**SUBJECT: South Orange County Transportation Infrastructure Improvement Project
NWU:18-2006064.02:haasj
Section 401 Certification Resubmittal and Response to Comments**

SOUTH ORANGE COUNTY TRANSPORTATION INFRASTRUCTURE IMPROVEMENT PROJECT (SOCTIIP)
SECTION 401 CERTIFICATION/WDR RESPONSE TO COMMENTS
(Updated 1/4/08)

SUBJECT: **FOOTHILL TRANSPORTATION CORRIDOR-SOUTH
RUNOFF MANAGEMENT PLAN SUPPLEMENTAL
DOCUMENTATION**

Figure 7-1 Proposed SFB Design Details

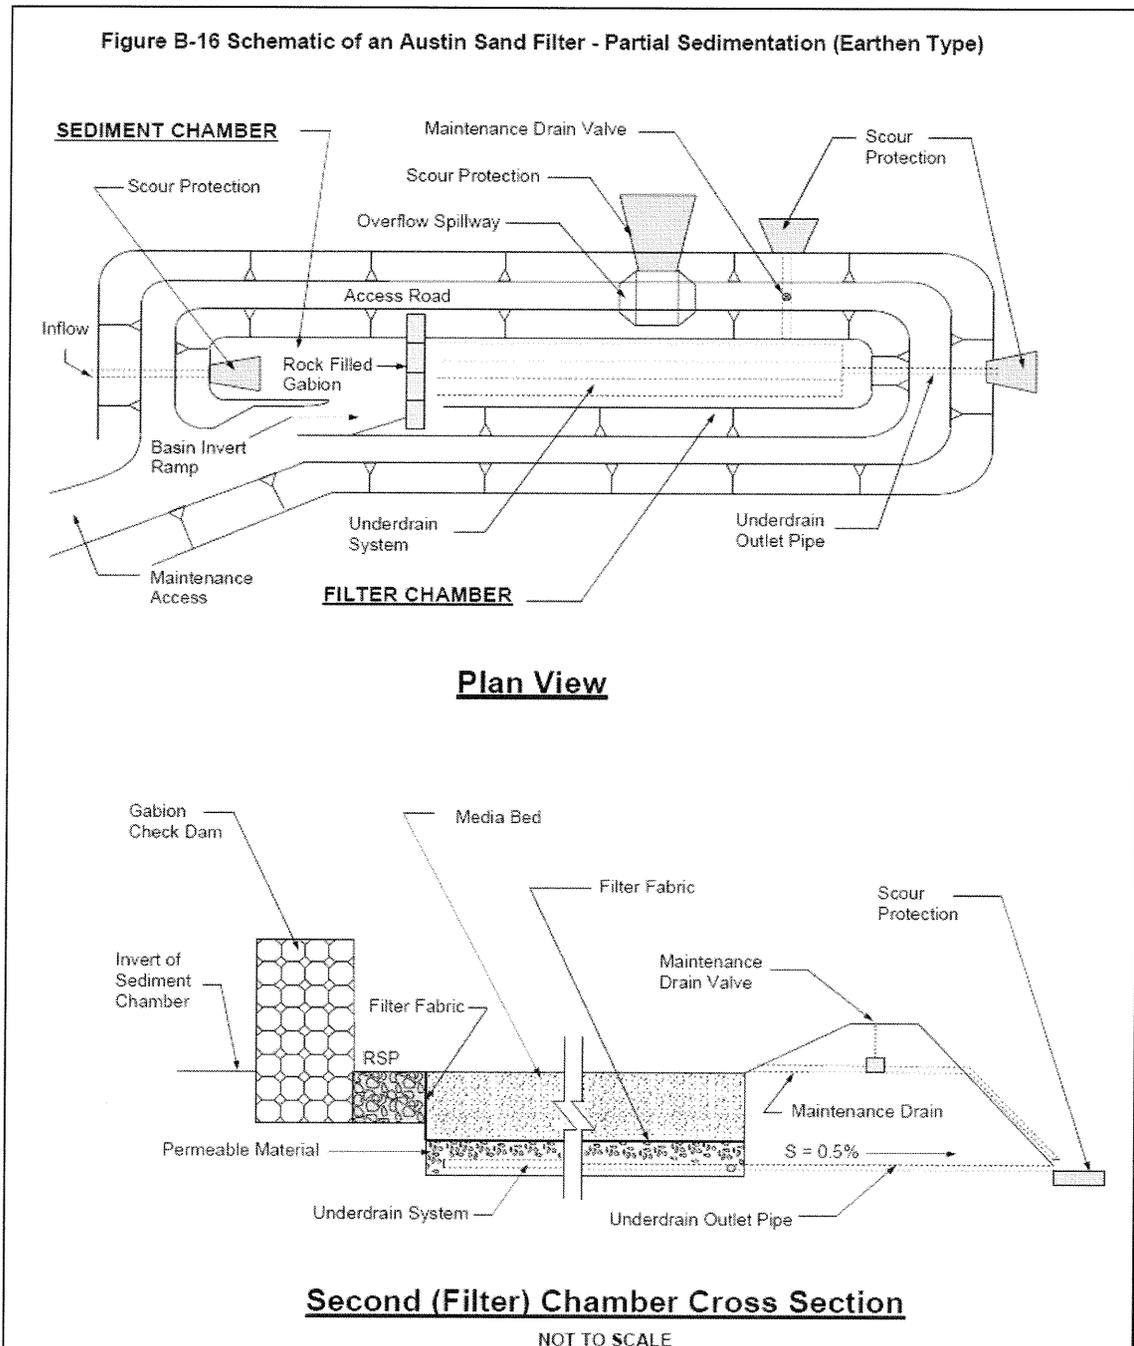
- *Comment 4: The BMPs as selected and designed may not provide sufficient treatment, especially EDBs near the San Mateo and San Onofre creeks. For example, the size of the particles with adsorbed pollutants expected may not be contained in the EDBs.*

- *Comment 5: The RMP dismisses media filters without the level of review called for by the 2007 PPDG.*
- *Response 5: As indicated in response 4, media filters are being proposed in the vicinity of San Mateo and San Onofre Creeks. The attached BMP exhibits have been revised accordingly.*

- *Response 4: The most recent Caltrans "Stormwater Monitoring and BMP Development Status Report" (2007) indicates that particulate matter greater than 50 micrometers (silt to fine sand size particles) in diameter was shown to completely settle out with detention times of 24-hours using EDBs designed to Caltrans standards. If the detention times are increased to 72-hours, particulate matter greater than 0.5 micrometers (clay size particles) in diameter will settle out. In the project vicinity, 50 boring logs were evaluated to assess particulate size. Alluvial valleys exhibited deep soil profiles consisting of silty to fine grained sands with some gravelly sands while the hillsides exhibited shallower soils consisting of finer grained silty to clayey sands. In order to provide for sufficient settling time in the EDBs, the outlets will be designed for a 72-hour drawdown time. This has no impact on the size of the basin, just on the outlet size. In this way, the particulate matter in this vicinity will settle out in the EDBs. Note that the EDBs originally proposed near San Mateo and San Onofre Creeks have been revised to media filters. The revised Section 7 of the RMP has a more detailed description of this analysis.*

Media filters primarily remove particulates from runoff by sedimentation and filtration and also are effective for removing dissolved metals and litter. An "Austin" sand filter typically has an open top, is designed at grade, has no permanent water pool and requires sufficient hydraulic head to operate by gravity (3 feet). It may be configured with earthen sides or concrete sides and invert. This style of sand filter basin (SFB) has been proposed for the FTC-S project. A schematic of the SFB is shown in Figure 7-1 from the Caltrans PPDG (May 2007). Note that a partial sedimentation sand filter is proposed at this level of design. The earthen type requires 3:1 side slopes with at least 10-ft separation between the top of the media bed and the seasonally high groundwater along with a 2:1 length to width ratio in the sedimentation chamber. If the groundwater is too high, a vault type sand filter with concrete bottom and sides is required. Approximately 3 to 6 ft of drop will be required between the inflow and outflow. The filter bed will include a 1.5 ft layer of sand (with coefficient of permeability of 2 inches/hr) underlain by filter fabric and a 1-ft layer of gravel (permeable material) with a 6-inch perforated underdrain system. The design drain time for the filter bed will be 24 hrs and the maximum height of water for the WQV in the device will be 5-ft. The sedimentation chamber is designed to hold 20 percent (minimum) of the WQV while the filter chamber is designed to hold the rest.

Three SFBs are proposed along the alignment. Table 7-1 provides a synopsis of the media filter sizes and tributary areas. Note that the location for SFB 1 is still under coordination with MCB Camp Pendleton and SFB 2 must be vaulted due to high groundwater levels.

Figure 8-2a Flow Splitter Schematic

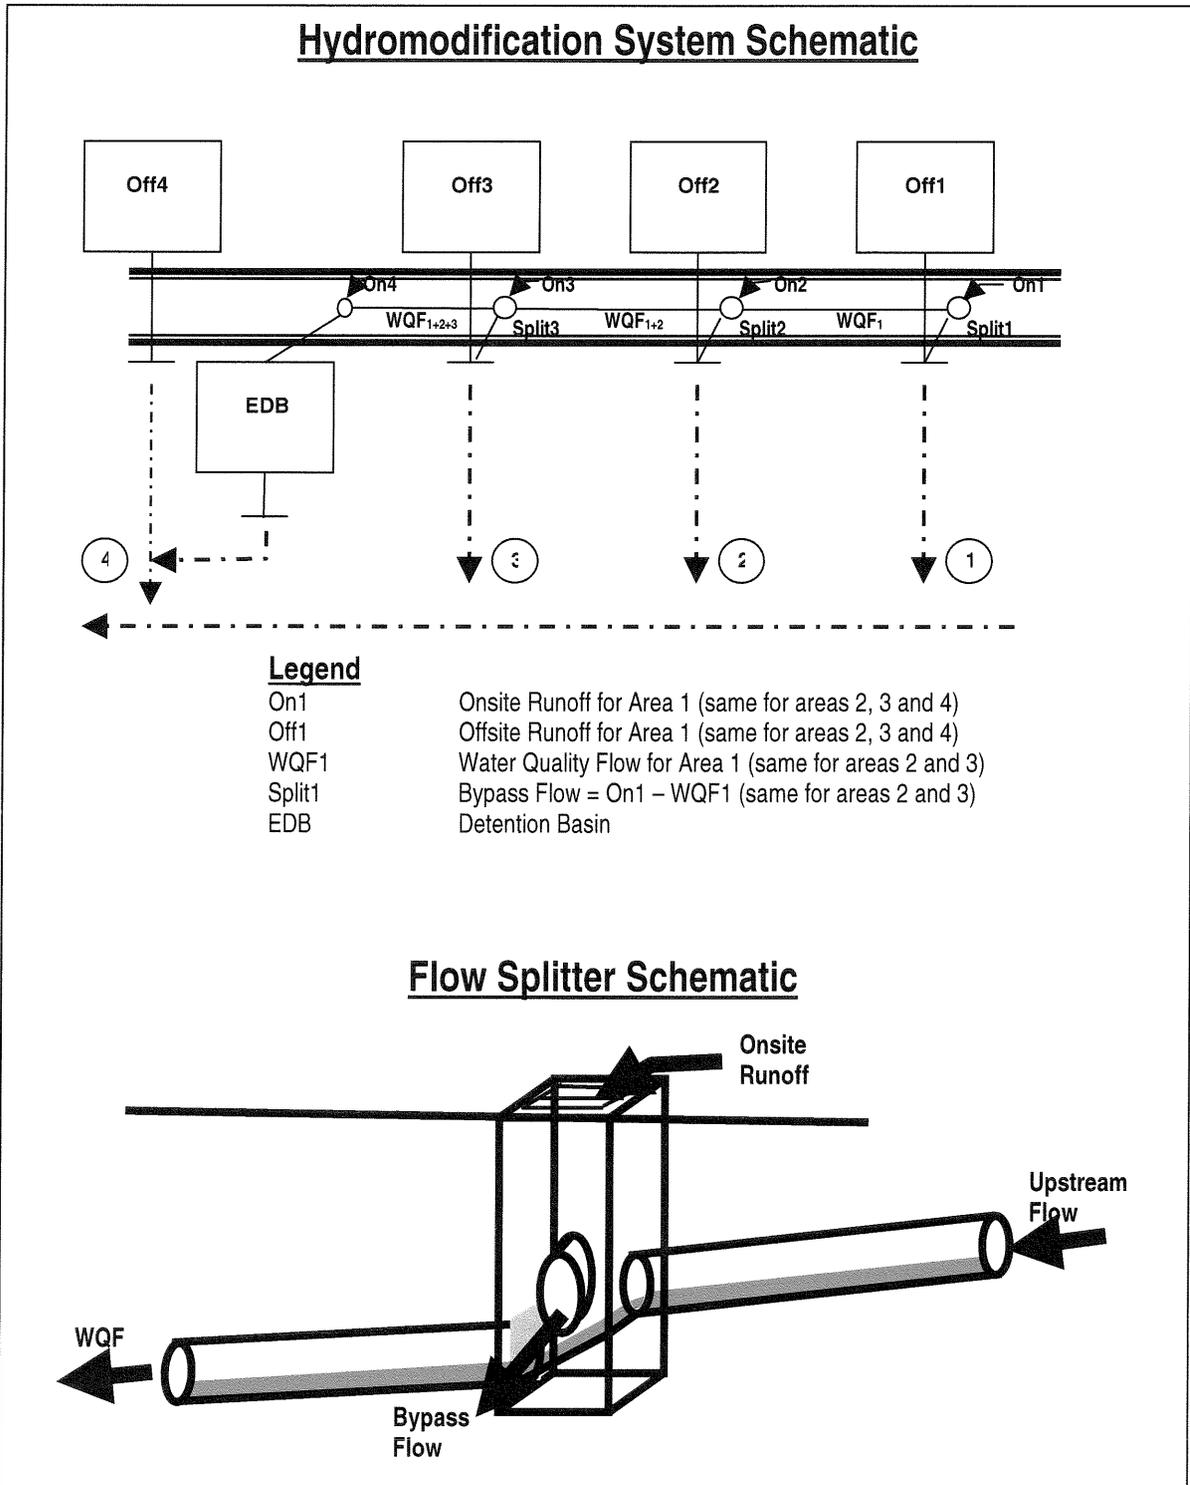
- Comment 1: One assumption is that the change in imperviousness in the drainage areas of the extended detention basins is insignificant relative to the entire drainage area of San Mateo and San Juan creeks. However, the change within the EDB drainage area is more important to assess discharge site-specific runoff effects.

- Response 1: *The overall imperviousness in the drainage areas of the extended detention basins was not provided since flow splitters are included in the on-site drainage networks that connect to the BMPs. The flow splitters are considered hydromodification facilities that serve to reduce any flow increase resulting from the additional imperviousness. Because of the inclusion of hydromodification facilities, the comparison of flow rates rather than impervious area is a better reflection of any potential minor changes that may occur to the flow regime. Additional information has been provided which relates 2-year storm flows from the detention basins and 2-year off-site storm flows from the sub-watershed of the outlet channel. Two year on-site and off-site storm flows are shown in the revised Table 7-1 of the RMP.*

Flow splitters were simulated within the SWMM model assuming a side flow orifice located at the invert of an inlet structure with an orifice coefficient of 0.66. The high flow bypass pipelines were placed 1 foot higher than the orifice invert. The orifice size was calculated using the estimated water quality flow (WQF) with a head of 1 foot acting on the orifice. A minimum opening height of 4 inches was used to minimize potential clogging. The splitters were placed at most of the offsite drainage culvert crossings. Figure 8-2a provides a schematic of the flow splitter and shows its placement in the overall hydromodification systems.

Figure 8-3 Representative Flow Duration Curves at Flow Splitter Outfalls

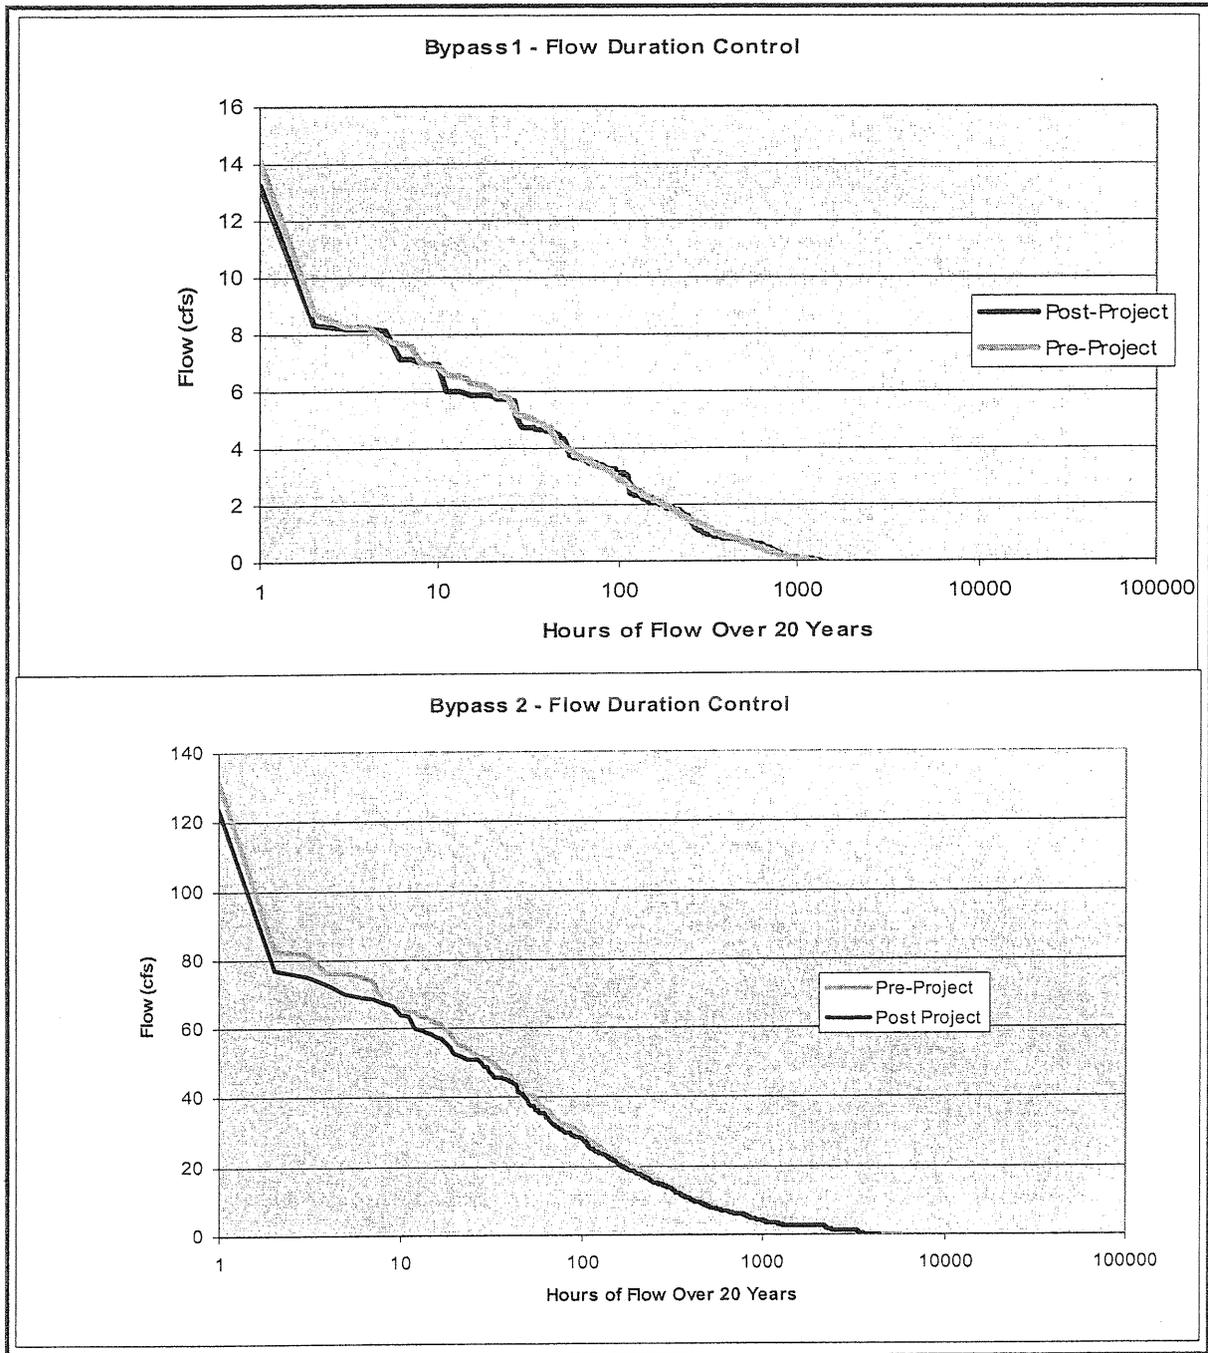
- *Comment 3: The flow duration curves were done for 2 (of 48) flow splitters, but those are for basins in which the EDB drainage areas are the lowest percentage of the receiving water's drainage area. How does that affect the overall assumption for bypassed flows?*

- *Response 3: The flow splitter duration curves are taken at the outlet of the flow splitters where the flow enters the hillside channel adjacent to the road, well upstream of the EDBs. The percentage of overall EDB drainage area to receiving water body drainage area does not enter into the analysis. The flow splitter analyses were performed for locations that include one small sub-watershed and one large sub-watershed. These represent the full spectrum of sub-watershed sizes along the alignment.*

Figure 8-3 shows the results of the two simulations. Bypass 1 represents a flow splitter outfall along a small drainage course in the EDB-6 drainage network, while Bypass 2 represents a flow splitter outfall along a large drainage course in the EDB-7 drainage network. A total of 42 flow splitters are proposed for this project, as shown in the exhibits in Appendix A.
